**Shaolin Tourist & Residential Development**  
**Comberton Grange, South Nowra, NSW**  
Response to Environmental Assessment Submissions  
MP06\_0135

December 2013

**RESPONSE TO ENVIRONMENTAL ASSESSMENT SUBMISSIONS  
& PREFERRED PROJECT REPORT****MP06\_0135: Tourist and Residential Development, Comberton  
Grange, South Nowra, NSW****1.0 INTRODUCTION**

Figure 1: Draft Shoalhaven LEP – Zoning Map

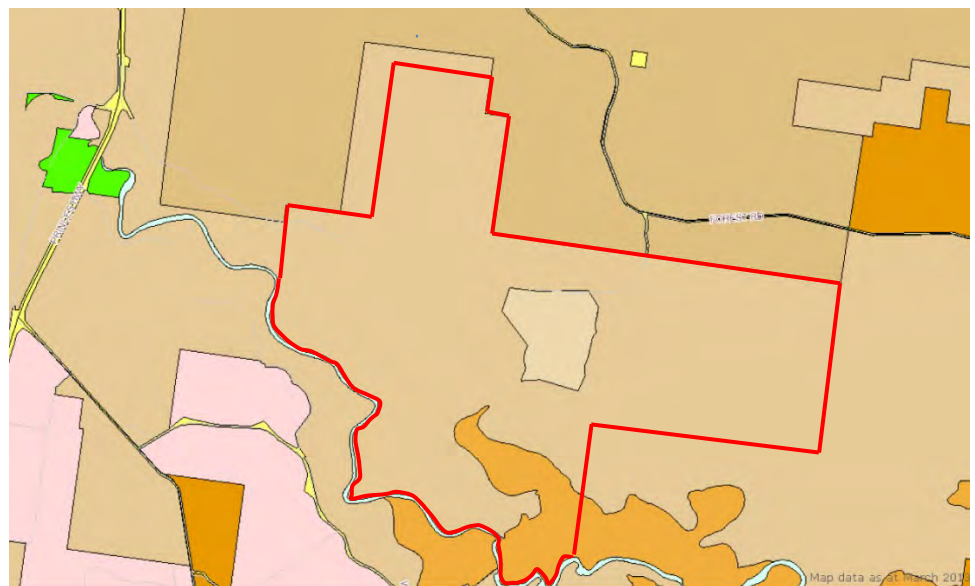
The Office of Environment & Heritage recommends that the eastern portion of the site, wetlands and riparian corridor should be zoned **E2 Environmental Conservation** under *Shoalhaven Local Environmental Plan 2012* (SLEP) 2012.

Currently, Shoalhaven LEP (Figure 1) has identified the:

- Eastern portion of the site (except for the quarry and its curtilage) as zoned **RU2 Rural Landscape**; and
- SEPP 14 wetlands (at the south-eastern portion of the site) as zoned **E2 Environmental Conservation**.

The proponent proposes that the portions of the site:

- to the **east of the quarry** be zoned **E4 Environmental Living**; and
- **wetlands and riparian corridors** along the major tributaries of Georges Creek and along Currumbene Creek be zoned **E2 Environmental Conservation**.

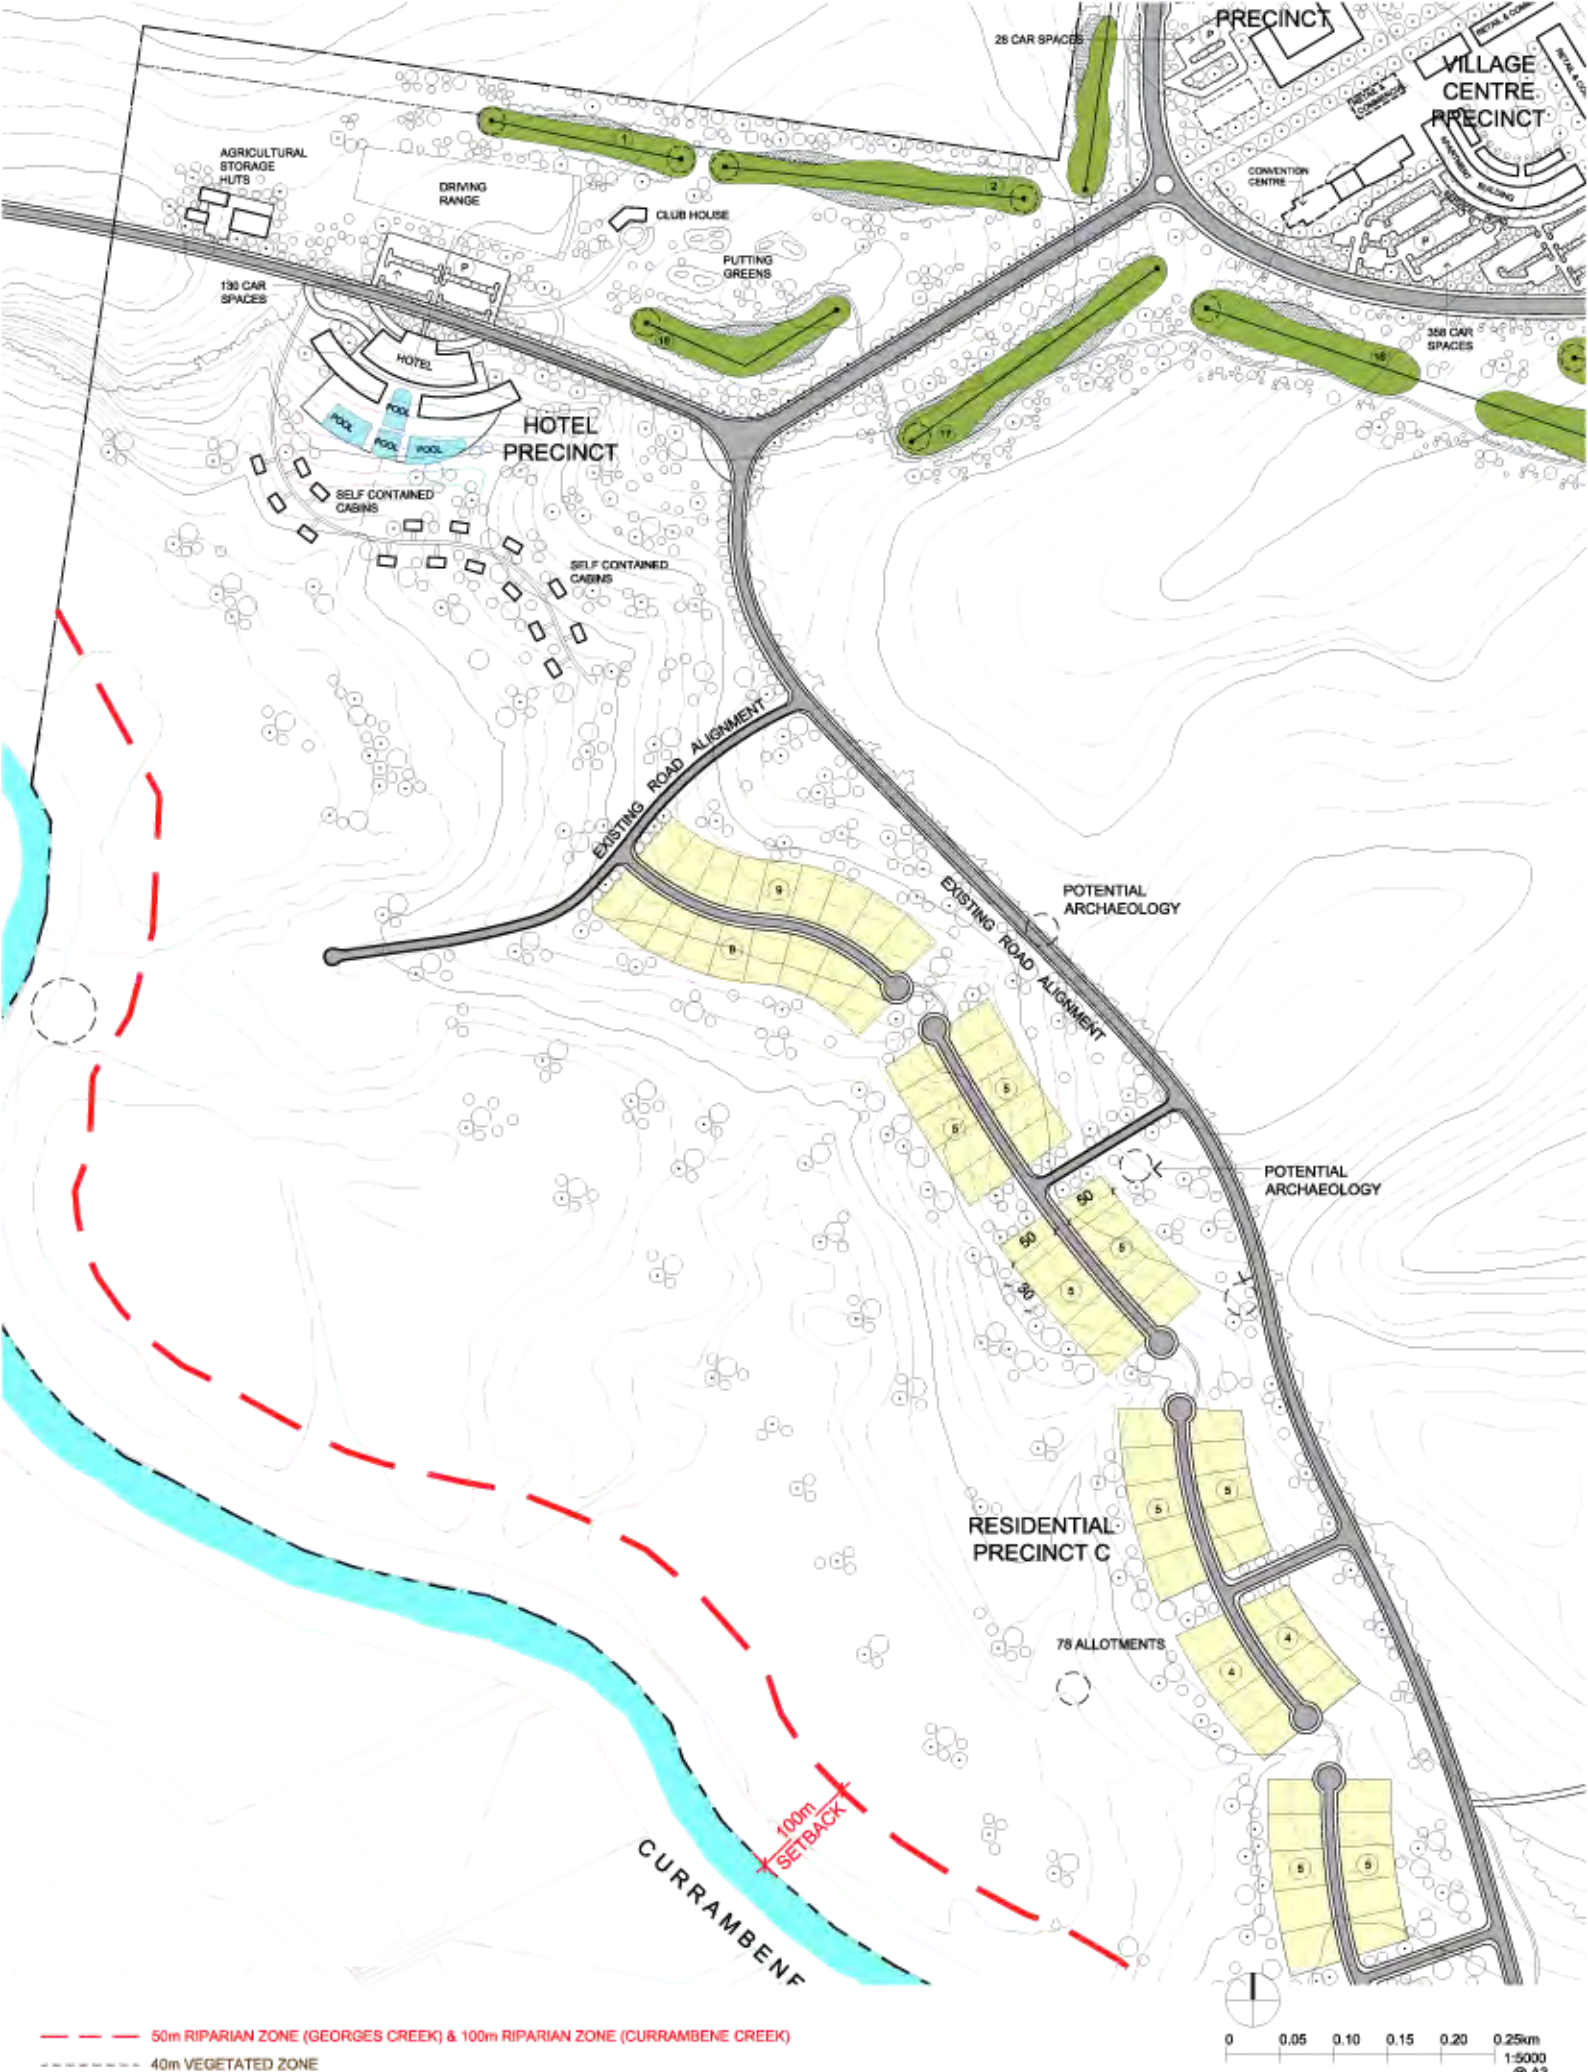
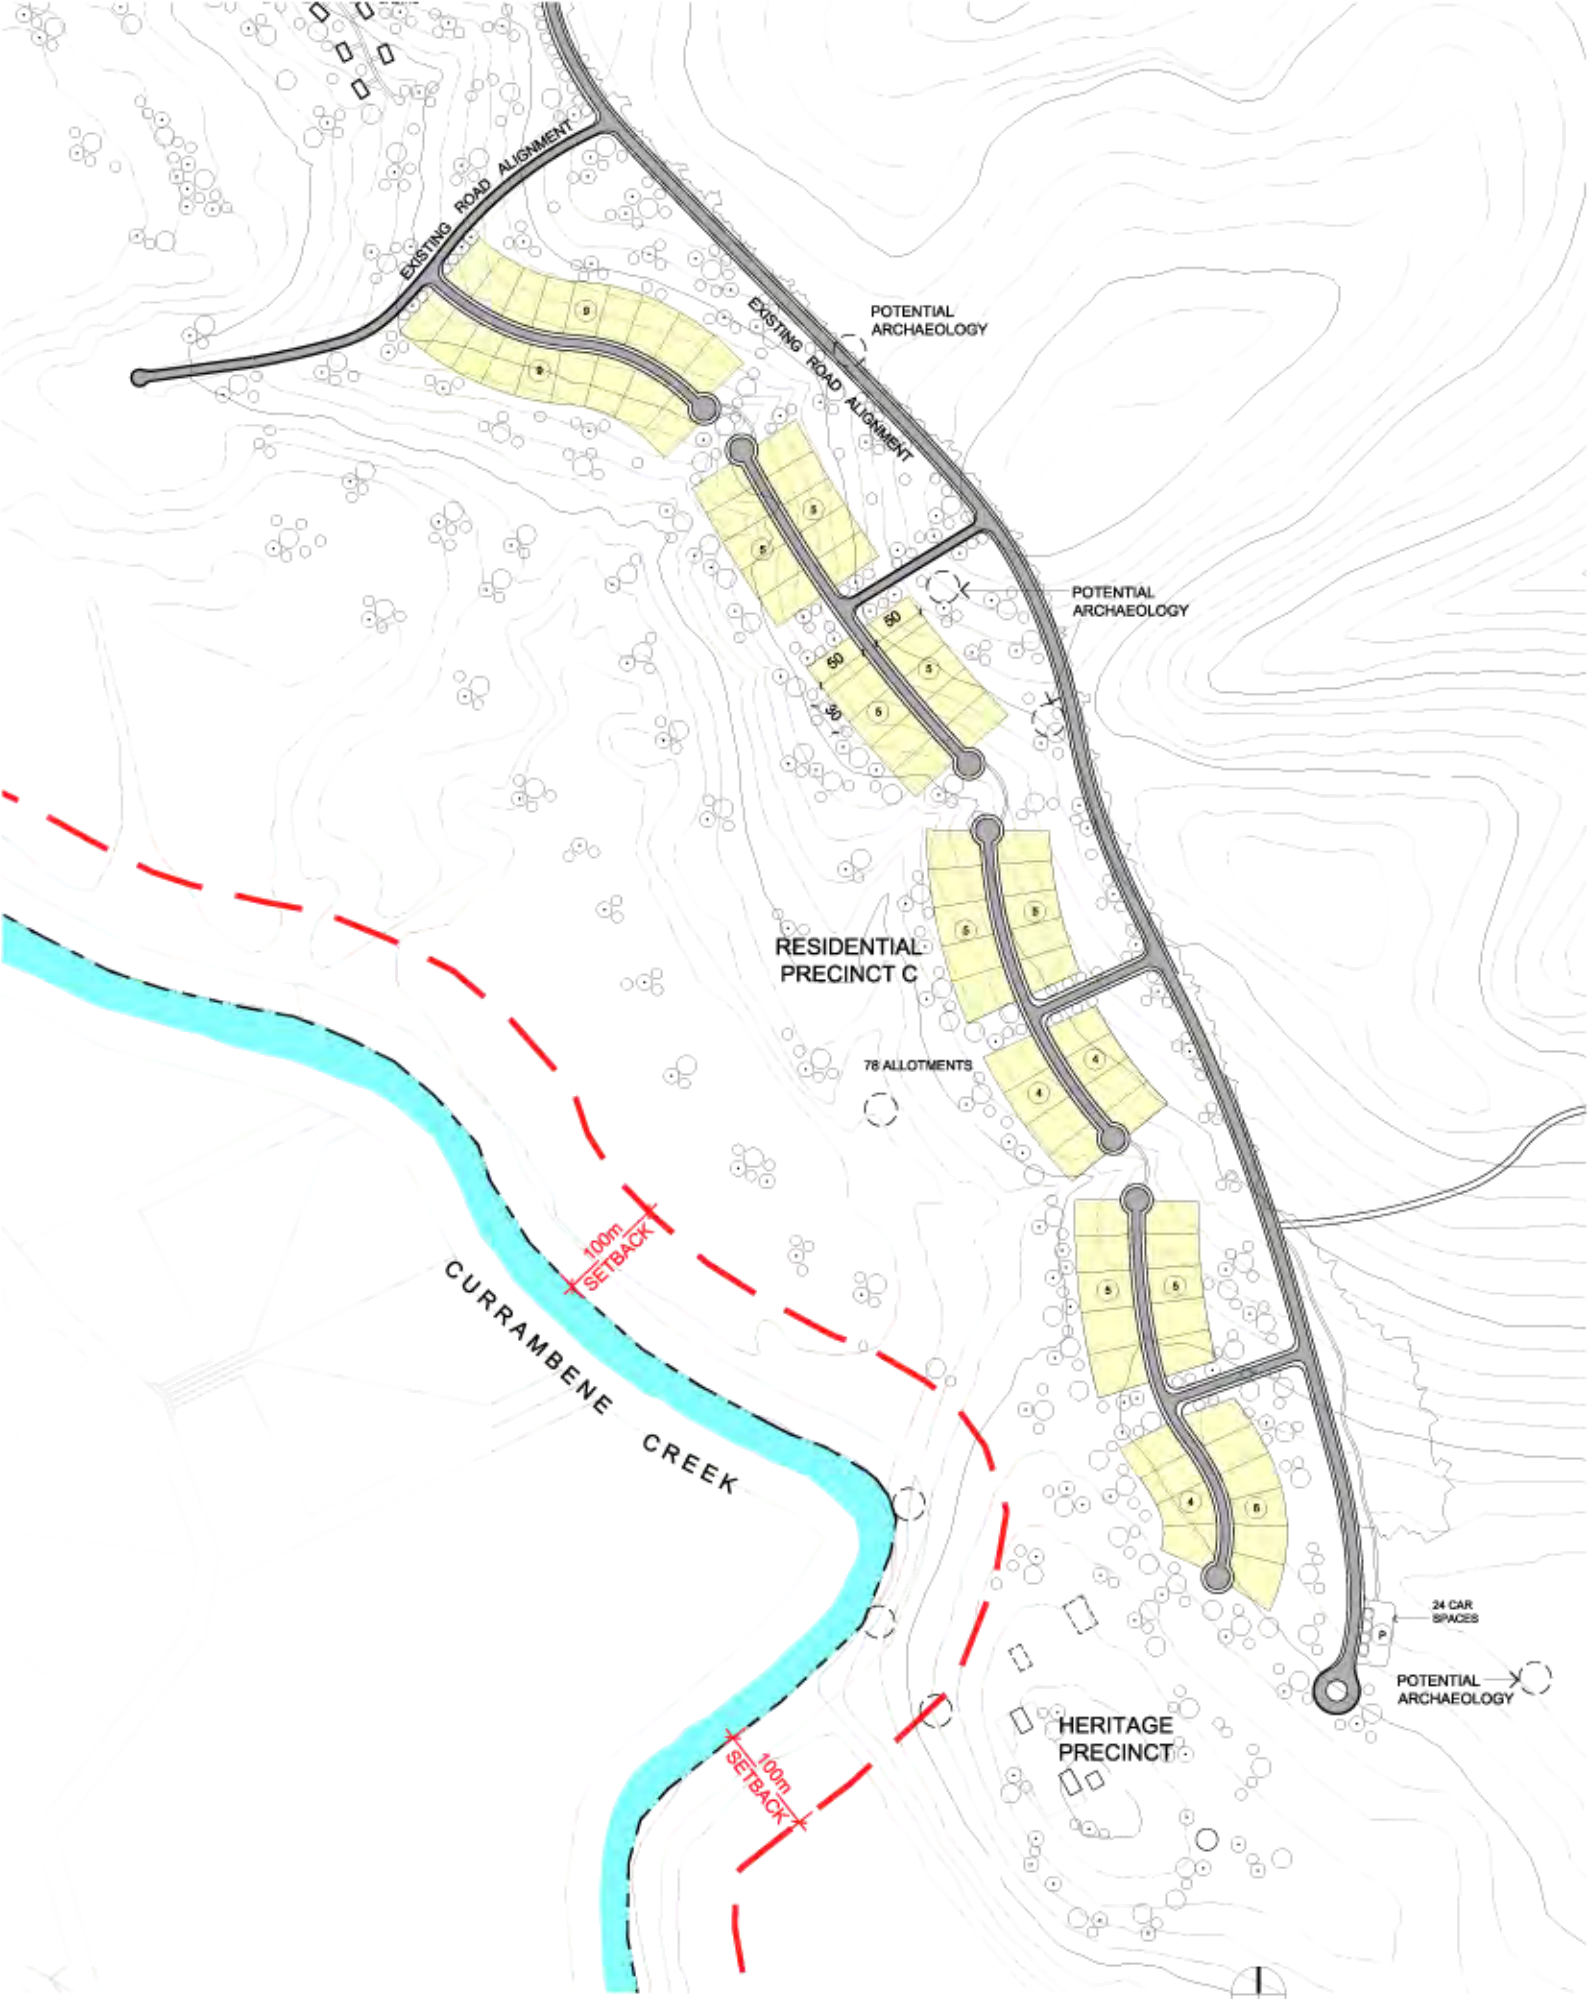
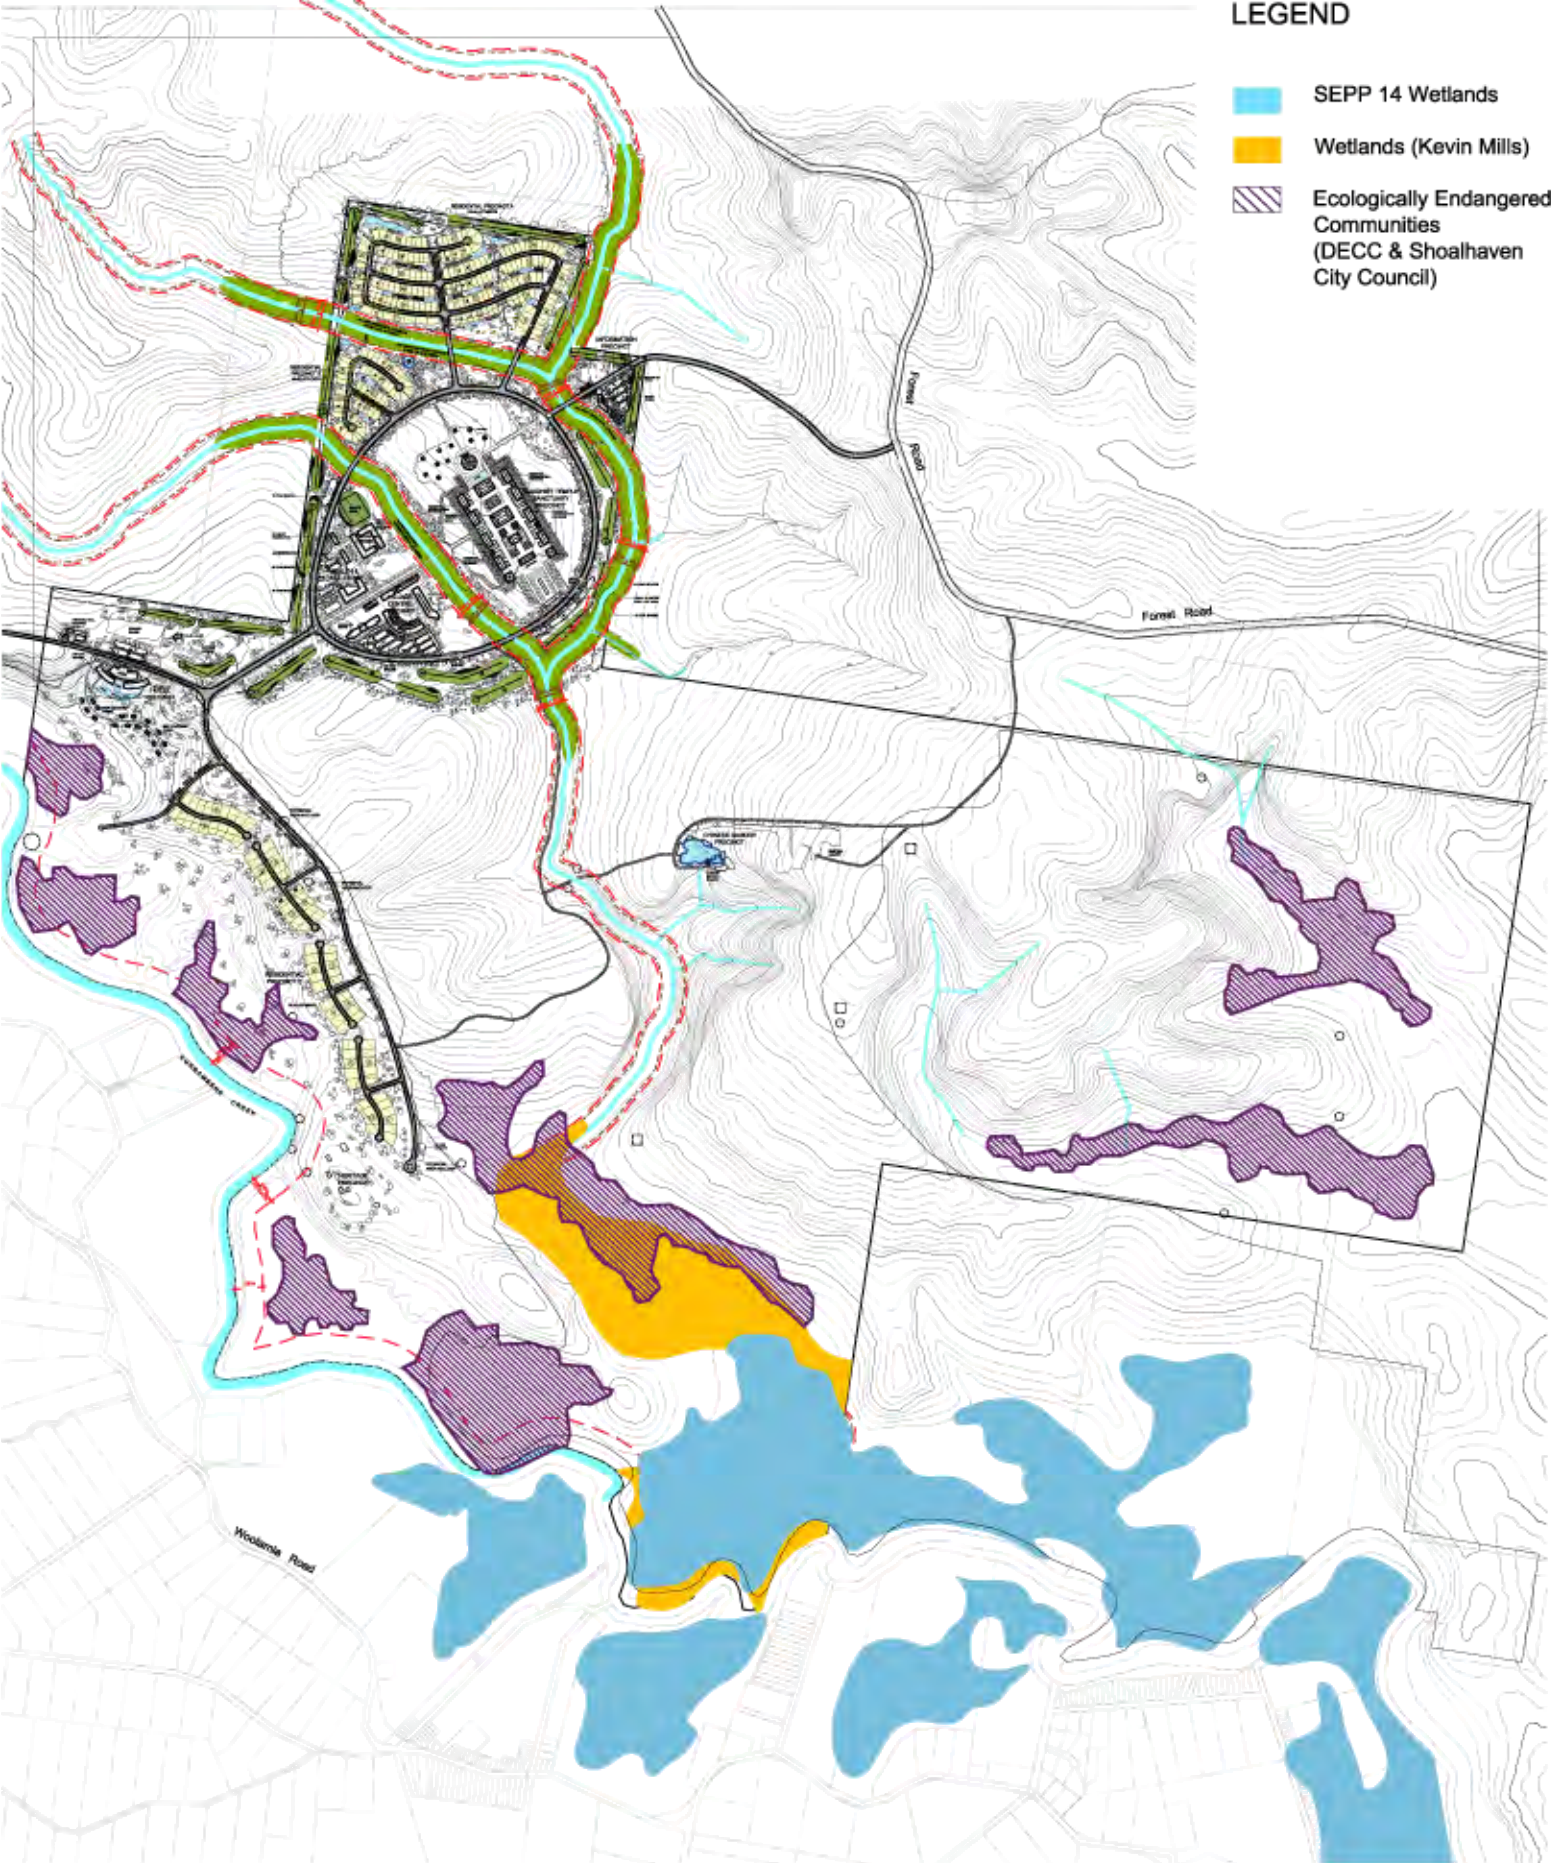
Riparian areas are to be illustrated on a plan which clearly shows the proposed development footprint and the riparian corridor widths either side of the creeks and the SEPP 14 wetland. This plan must be referenced with an appropriate legend illustrating a:

- 50m riparian zone for Georges Creek (40m fully vegetated and a 10m buffer on each side of the creek);
- 100m riparian zone for Currambene Creek and the SEPP 14 wetlands; and
- Relevant setbacks for the minor and major creek lines of Georges Creek.

Setbacks as outlined above will be complied with.

- Minimum 50m setback from Currambene Creek – 100m setback provided; and
- Minimum 30m clear of minor creeklines of the Georges Creek system – 50m setback from either side of other creeks on the site.

Plan of riparian corridors illustrating the above is attached. The Statement of Commitments will acknowledge the maintenance of these setbacks.
